| Version history                                                                    |                                                                           | PRODUCT GRAPHIC DRAWINGS                                |            |
| Project: GSHM1BT                                                                   |                                                                           | Design Lead: Yannick Lenormand                          |            |

Artwork (scale 1:1)

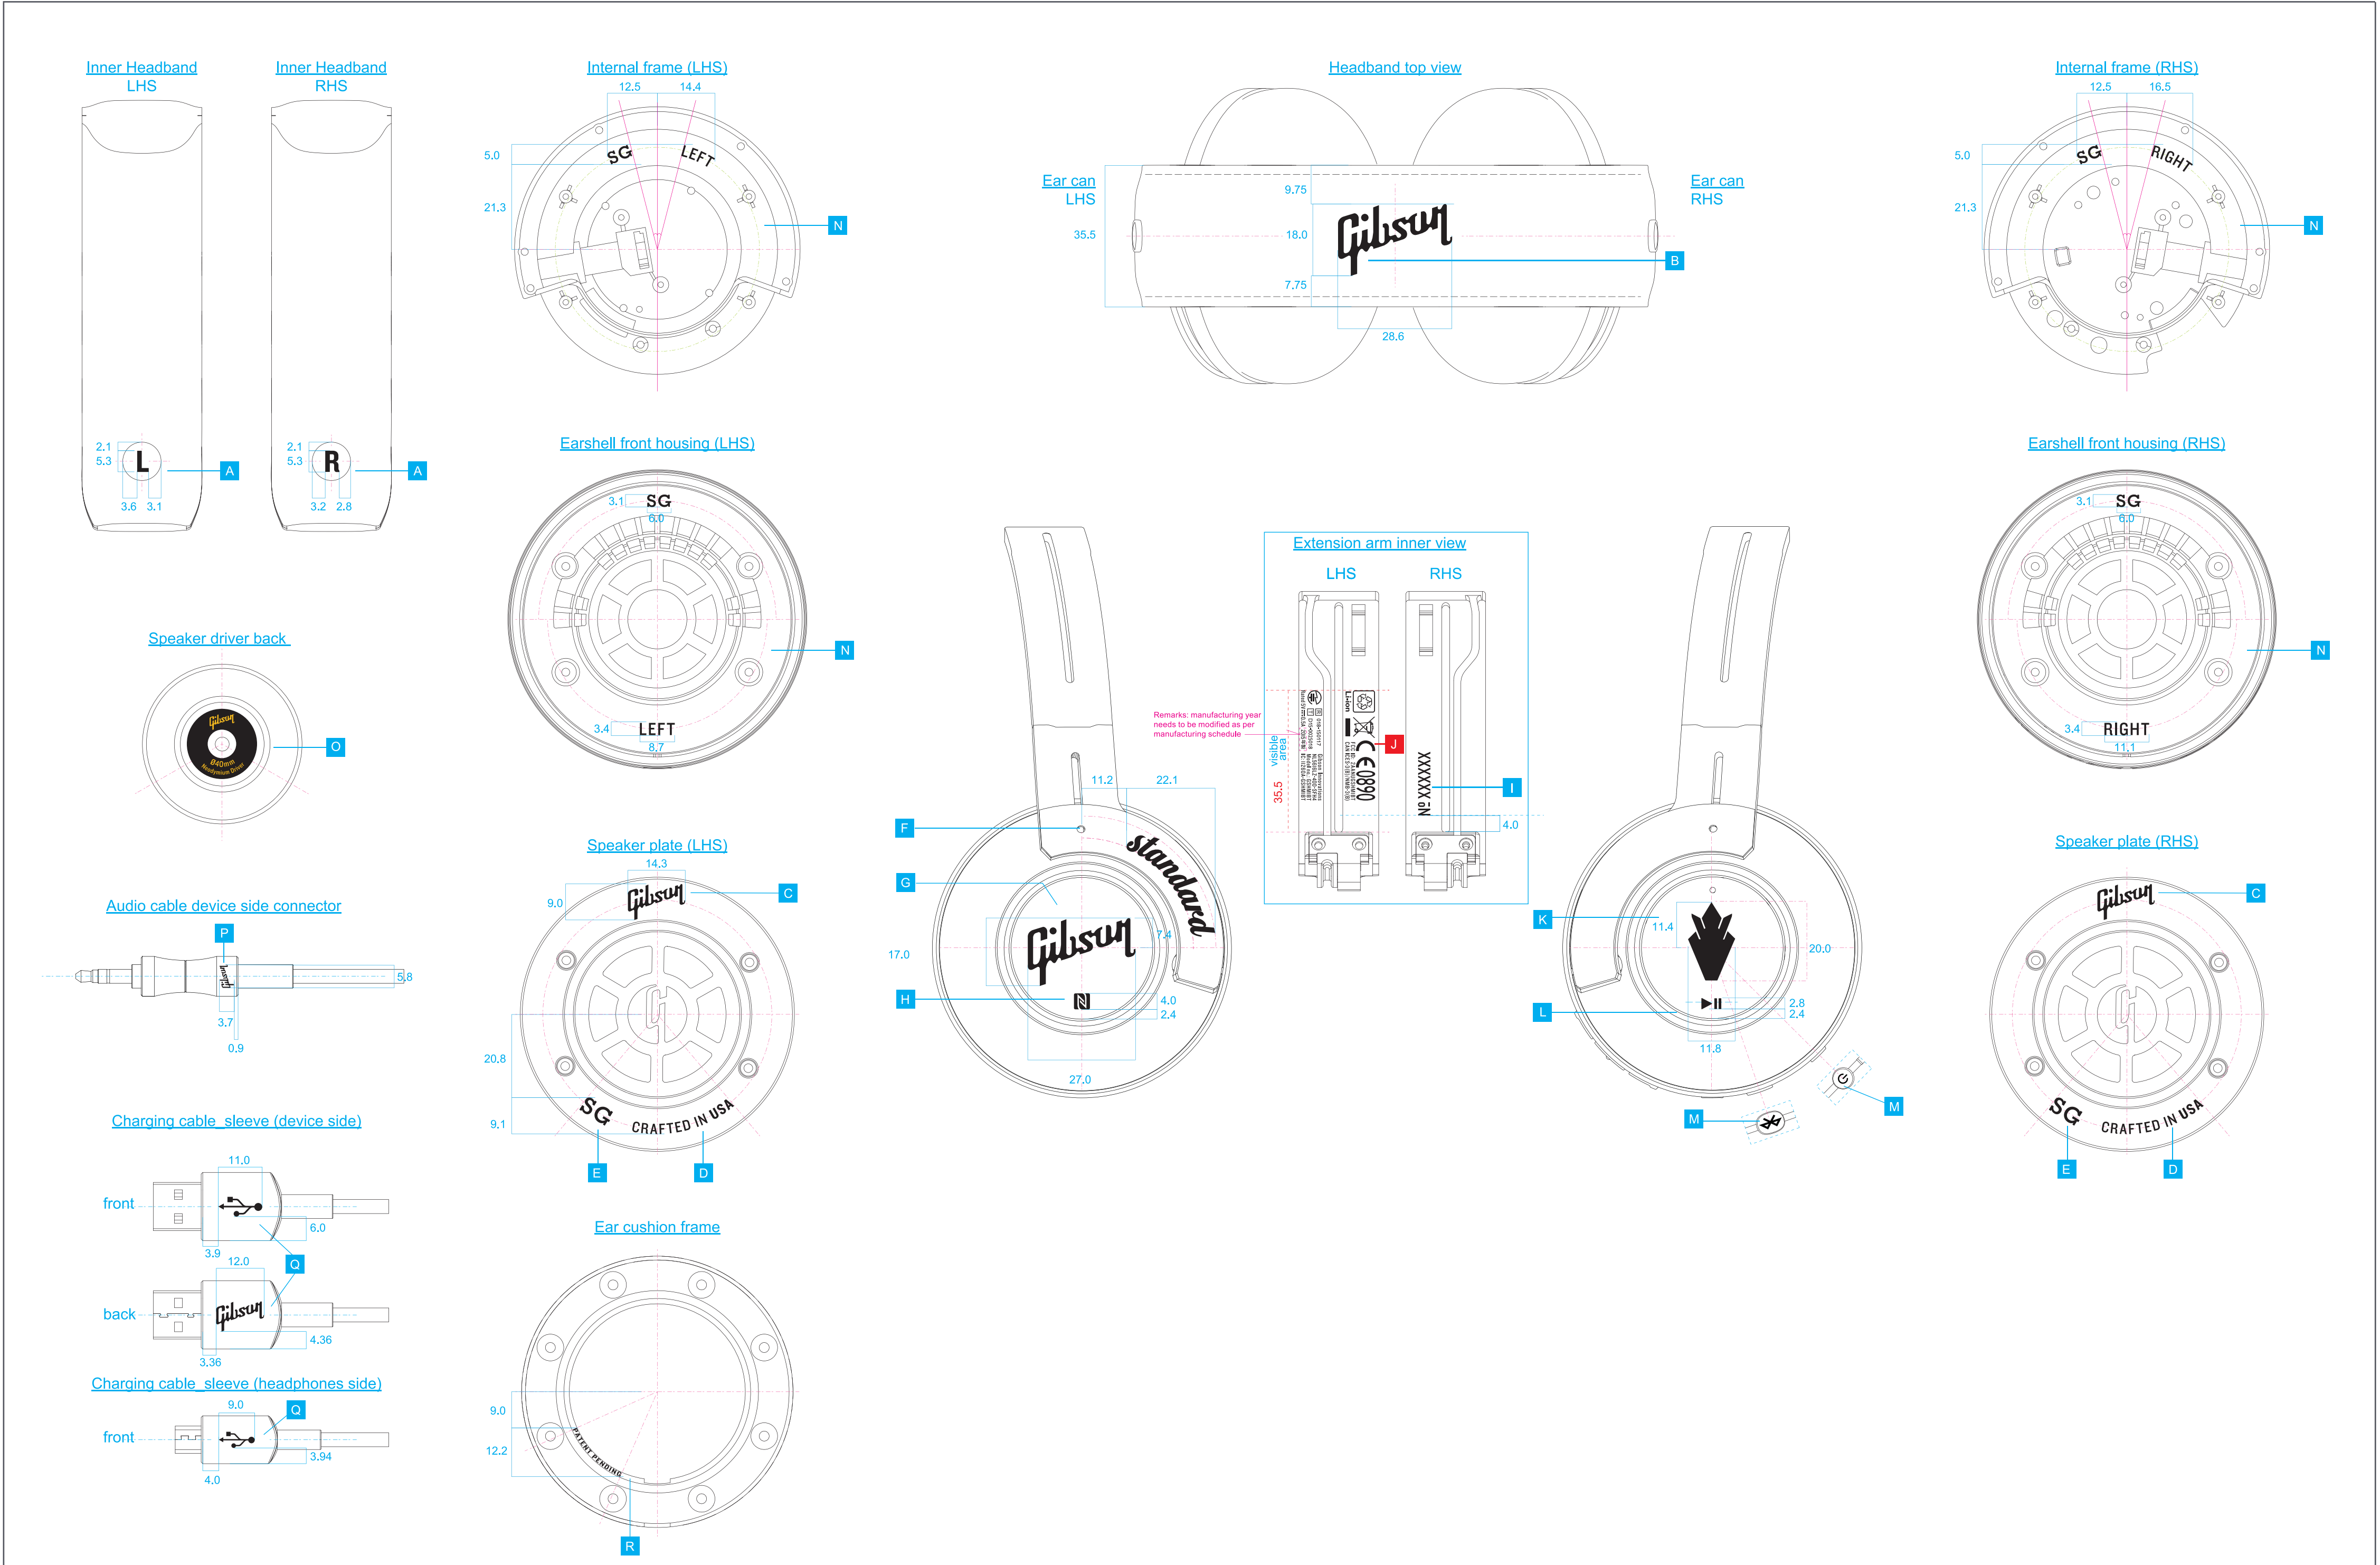
| PART | COLOUR                                                           | TECHNIQUE                                   | CHANGES / REMARKS                         | VER                                                                                                                                                                                      |     |
|------|------------------------------------------------------------------|---------------------------------------------|-------------------------------------------|------------------------------------------------------------------------------------------------------------------------------------------------------------------------------------------|-----|
| A    | L & R graphics on inner headband pins                            | PMS Process Black C                         | Recess engraving ink filled               | The pin remain metal v4.0: updated typeface                                                                                                                                              | 4.0 |
| B    | GIBSON logo on headband top                                      | As per material color                       | Heat pressed                              | v3.0: updated vertical position. v4.0: updated new drawing                                                                                                                               | 4.0 |
| C    | GIBSON logo on speaker plate (LHS & RHS)                         | As per material color                       | Etched, recess 0.2mm                      | Etched before plating to preserve color. v4.0: updated new drawing                                                                                                                       | 4.0 |
| D    | 'CRAFTED IN USA' graphic on speaker plate (LHS & RHS)            | As per material color                       | Etched, recess 0.2mm                      | Etched before plating to preserve color. v2.0: updated graphics position. v4.0: updated new drawing, changed text to 'CRAFTED IN USA' and updated typeface                               | 4.0 |
| E    | 'SG' graphic on speaker plate (LHS & RHS)                        | As per material color                       | Etched, recess 0.2mm                      | Etched before plating to preserve color. v2.0: updated graphics position. v4.0: updated new drawing                                                                                      | 4.0 |
| F    | 'Standard' text on arm guard (LHS)                               | As per material color                       | Etched, recess 0.2mm                      | Etched before plating to preserve color v4.0: updated text 'Standard' font typeface & new drawing                                                                                        | 4.0 |
| G    | GIBSON logo on ear can (LHS)                                     | Gibson metallic gold (refer to guitar)      | Silkscreen                                | v4.0: updated new drawing & Gibson logo size                                                                                                                                             | 4.0 |
| H    | NFC icon                                                         | PMS Black 7C                                | Silkscreen                                | v4.0: updated new drawing; v4.3: updated technique                                                                                                                                       | 4.3 |
| I    | Limited edition number on extension arm inner (RHS)              | As per material color                       | Laser etched, recess 0.1mm                | v3.0: updated size, gaphics and position v4.0: laser etched after plating                                                                                                                | 4.0 |
| J    | Approbation on extension arm inner (LHS) (to be confirmed)       | As per material color                       | Leser etched, recess 0.05mm               | v4.0: lazer etched before plating v4.4: updated approbation and CTN from GSH-M1B to GSHM1BT                                                                                              | 4.4 |
| K    | 'Holly CROWN' graphic on ear can (RHS)                           | Gibson metallic gold (refer to guitar)      | Silkscreen                                | v4.0: updated new drawing & graphics size                                                                                                                                                | 4.0 |
| L    | PLAY / PAUSE icon on button                                      | PMS Black 7C                                | Silkscreen                                | v4.0: updated new drawing & graphics size; v4.3: updated technique                                                                                                                       | 4.3 |
| M    | Power and Bluetooth icon                                         | As per material color                       | recess engraving 0.2mm, high gloss finish | v4.0: updated new drawing & graphics size                                                                                                                                                | 4.0 |
| N    | Graphic on earshell front housing and internal frame (LHS & RHS) | As per material color                       | Recess engraving 0.2mm, high gloss finish | v4.0: new added item                                                                                                                                                                     | 4.0 |
| O    | Label on speaker driver back (LHS & RHS)                         | Gold text (Gibson gold) on black background | Paper label                               | v4.0: new added item, label stick on the back of the magnet                                                                                                                              | 4.0 |
| P    | Gibson logo on audio cable device side connector                 | As per material color                       | Etched, recess 0.2mm                      | v4.0: new added item, etched before plating to perserve color                                                                                                                            | 4.0 |
| Q    | USB icon & Gibson logo on charger cable                          | As per material color                       | Etched, recess 0.2mm                      | v4.0: new added item, etched before plating to perserve color; v4.1: updated USB cable drawing, graphics and technique: etched before anodizing; v4.2: updated icon and Gibson logo size | 4.2 |
| R    | Graphic on ear cushion frame                                     | As per material color                       | Raised up engraving 0.1mm                 | v4.2: new added item; v4.3: updated technique                                                                                                                                            | 4.3 |
